Enclosed are the meeting minutes of the second meeting of NRC and DOE/NPO Preparatory to the submittal of the salt site site characterization plan (SCP). The attachments to the minutes are not enclosed since both NRC and DOE already have a complete set. If you have any questions please call Robert Johnson (FTS 427-4676) of my staff.

MINUTES OF THE SECOND MEETING OF NRC AND
DOE/NPO PREPATORY TO SUBMITTAL
OF SALT SITE SCP

JUNE 27-28, 1983
SILVER SPRING, MARYLAND

Figure 10.1 Technical program control: test plans and procedures (illustrative)

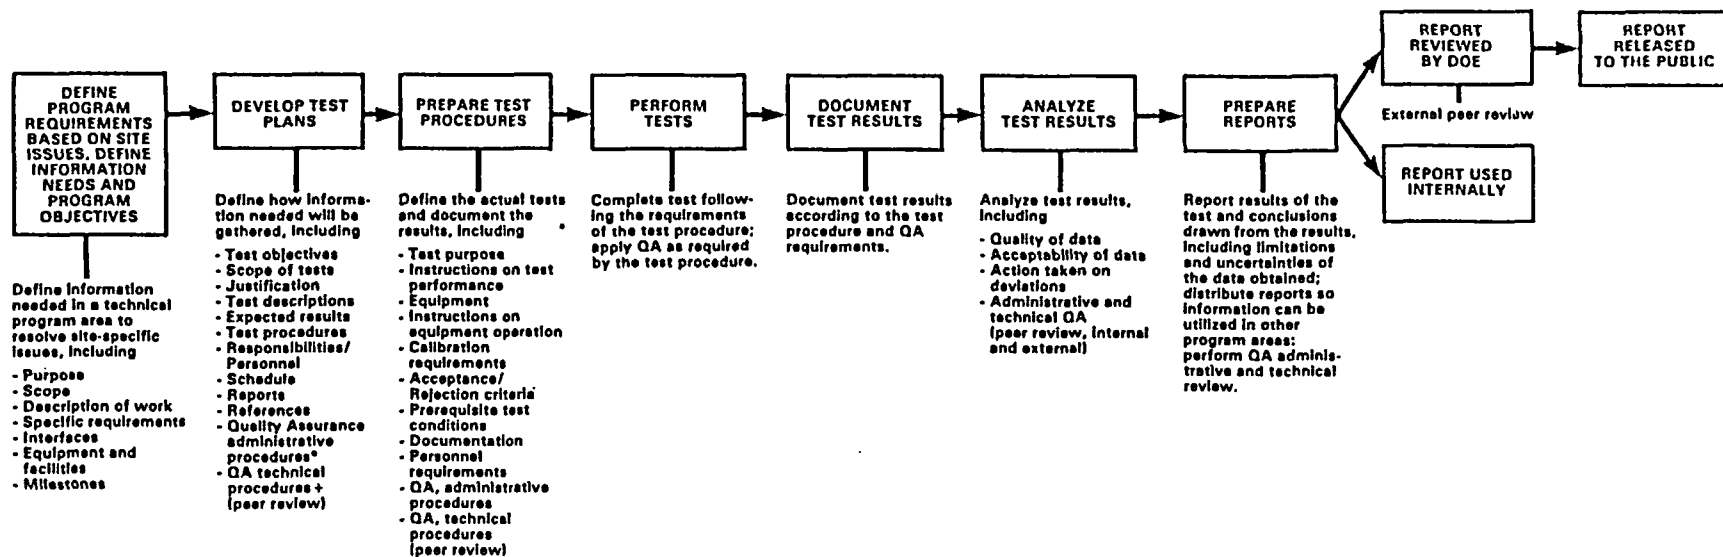
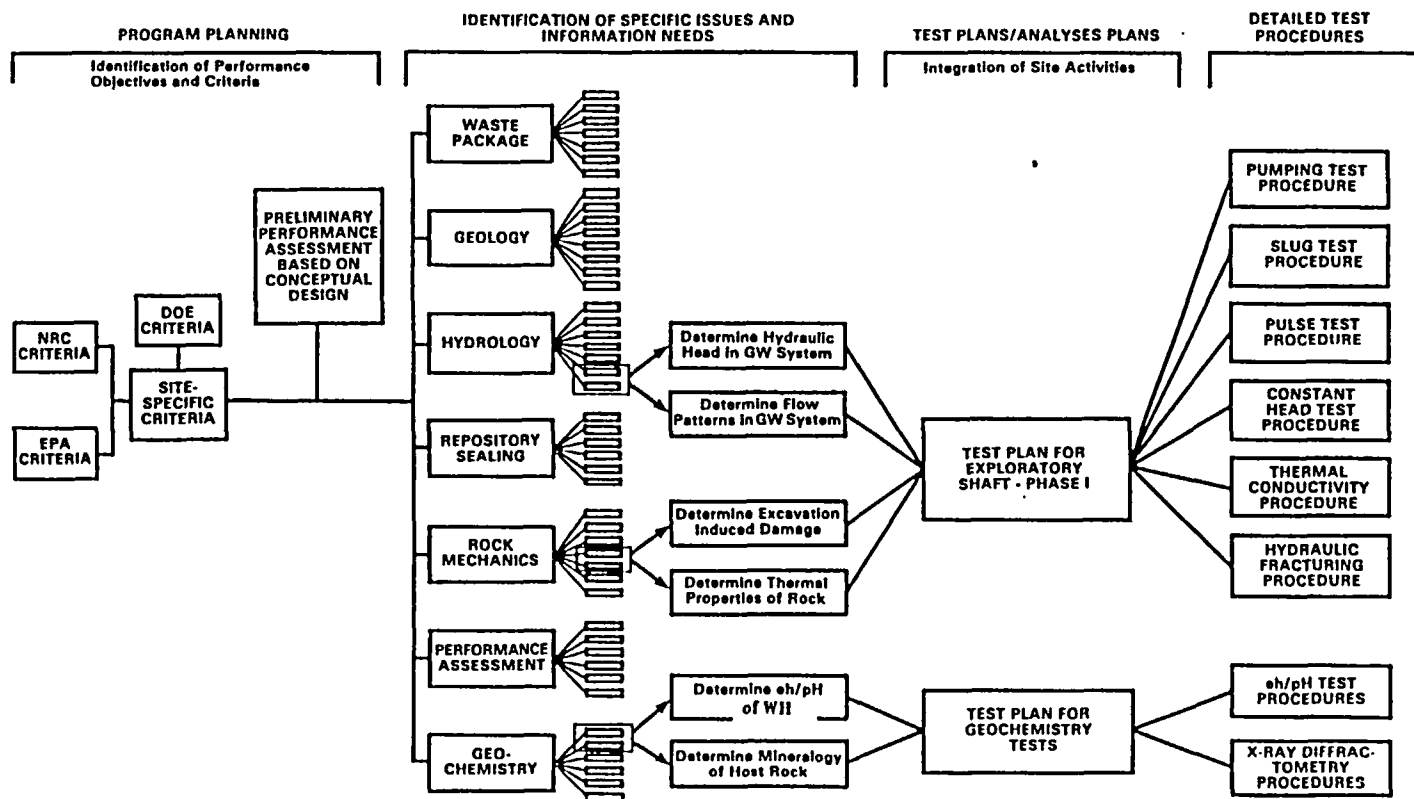
As shown in Figure 10.1, site characterization planning must start by considering EPA and NRC criteria. After a site is selected for further investigation, specific issues are identified, based on regulatory criteria and preliminary evaluation of repository performance.

In reviewing the SCR, the staff generally found that test plans and test procedures were not provided or referenced (see Figure 10.1). The SCR stops at the "information needs" level. The information presented is very general and does not give the staff enough detail to provide comments on test plans. Some procedures have been examined in previous workshops with DOE, but the staff expected this information to be at least referenced in the SCR. The staff recognizes that not all test plans and procedures may be needed at this time. However, some test plans (e.g., exploratory shaft and waste package development testing) should be available for QA review. Each chapter of this Draft SCA includes comments on the level of detail of the plans provided and gives examples of deficiencies.

Figure 2 ~~Systematic, iterative process~~
2 Systematic, iterative process
9-18

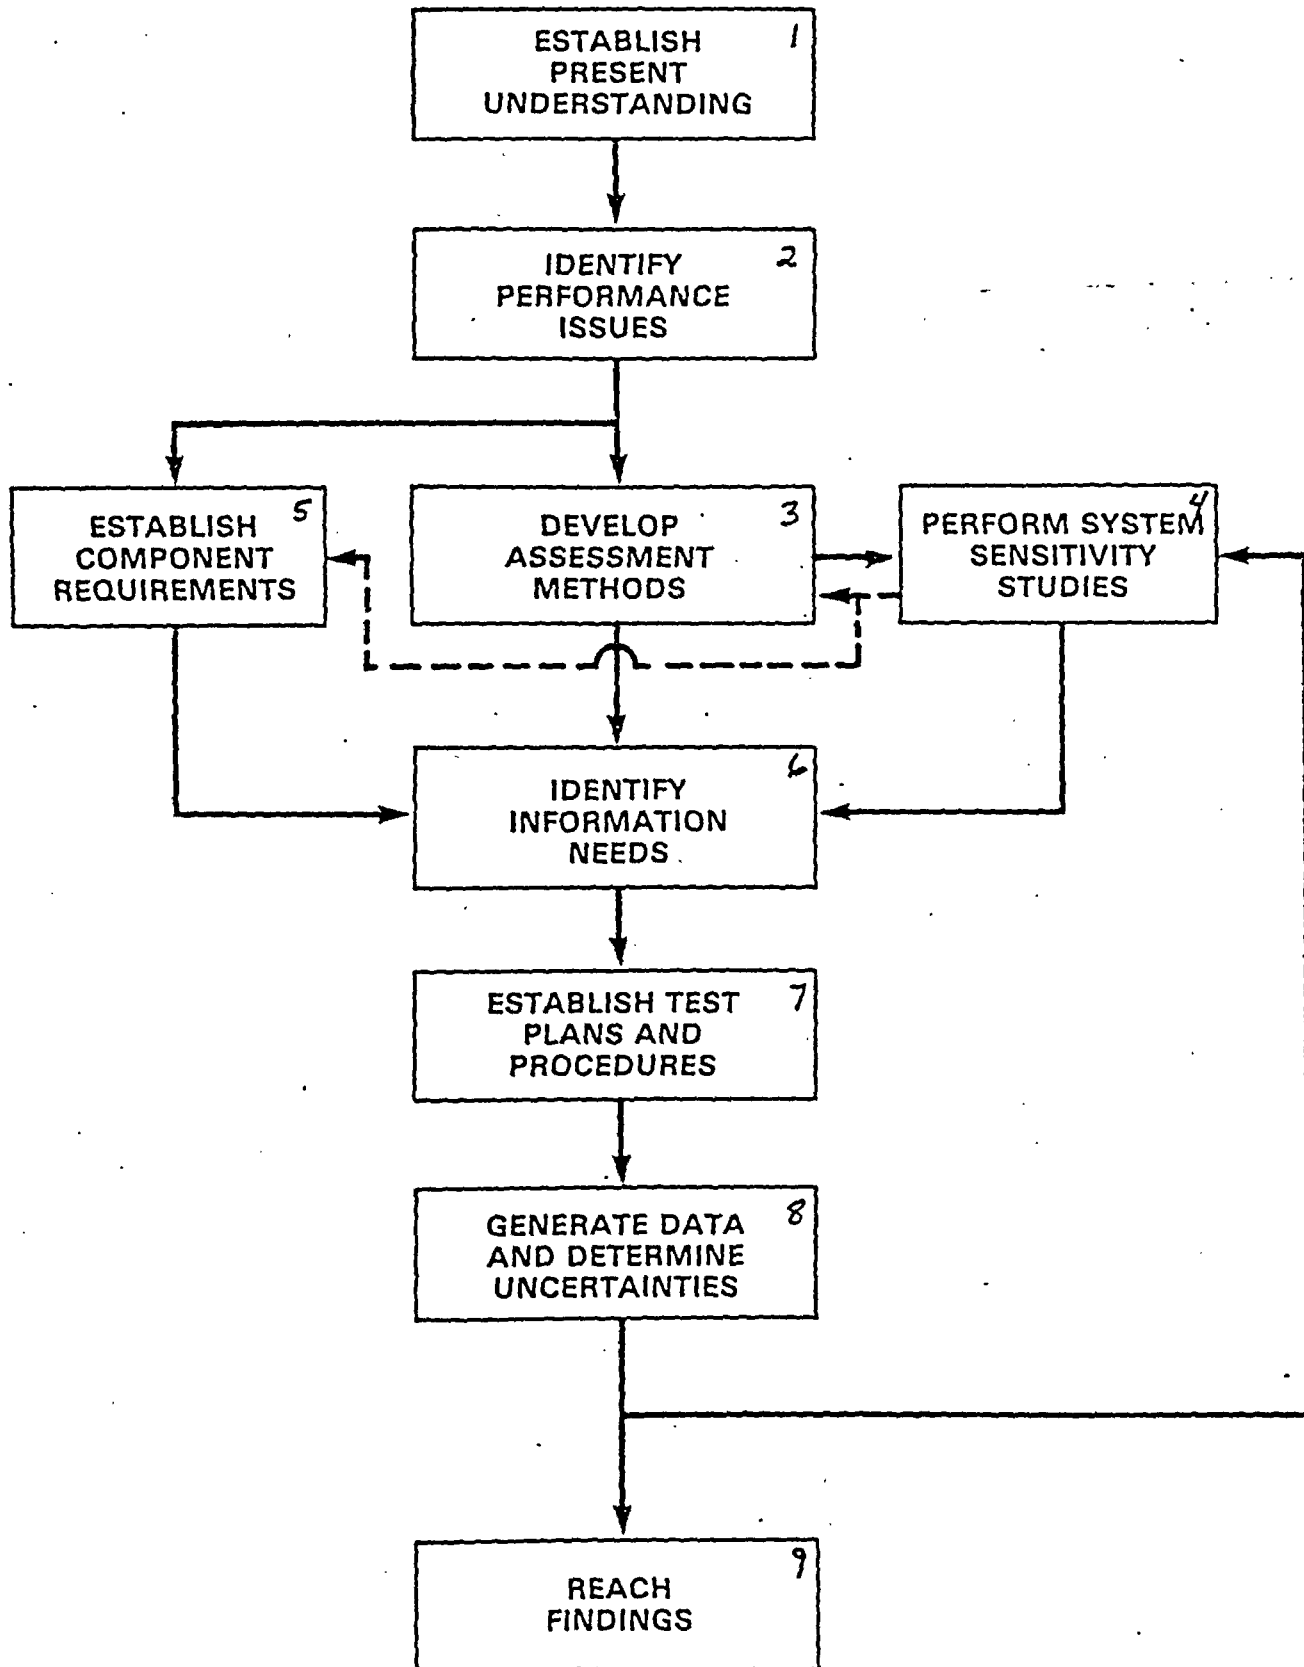
NRC response: DOE is in the best position to weigh all of the factors, including site specific factors and other, non-quantifiable programmatic factors such as cost, to propose what is a realistic and reasonable reliability level. Chapter 9, Figure 9.2, of the BWIP SCA describes the iterative process by which this should most appropriately occur (Attachment 10, figure 2).
